Service Information Bulletin

SUBJECT	DATE
SPN 520268 (MCM) (GHG17)	February 2016

Additions, Revisions, or Updates

2 SPN 520268/FMI 16 - GHG17

d500085

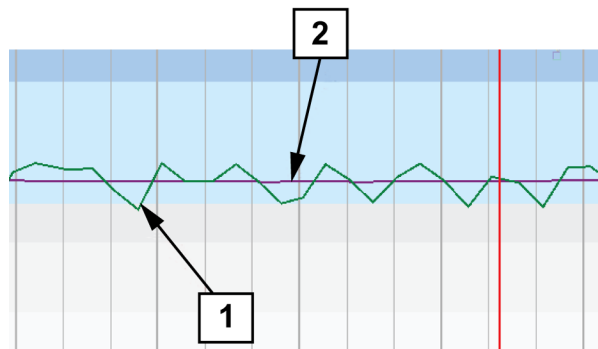
- a. Yes; Go to step 17.
 - b. No; Refer to section "Aerated Fuel Test – Two-Filter Fuel System".
17. Check the Idle Speed Balance (ISB) Values. Refer to section "Idle Speed Balance Test". Are there any cylinders above 70% or below -70%?
- a. Yes; follow repair procedures in "Idle speed balance (ISB) test" and verify repairs.
 - b. No; Go to step 18.
18. Is ASL001 Rail Pressure erratic or does it have a saw-tooth pattern?

NOTE: See examples of erratic pressure showing (1) ASL001 Rail pressure and (2) AS098 Desired rail pressure.

- a. Yes; Go to step 19.

- b. No; Go to step 20.
19. Perform the aerated fuel test. Refer to section "Aerated Fuel Test – Two-Filter Fuel System". Was fuel aerated?
- a. Yes; repair cause of aerated fuel. Refer to section "Aerated Fuel Test – Two-Filter Fuel System".
 - b. No; replace the Quantity Control Valve. Refer to section "Removal of the Quantity Control Valve - Two-Filter System".
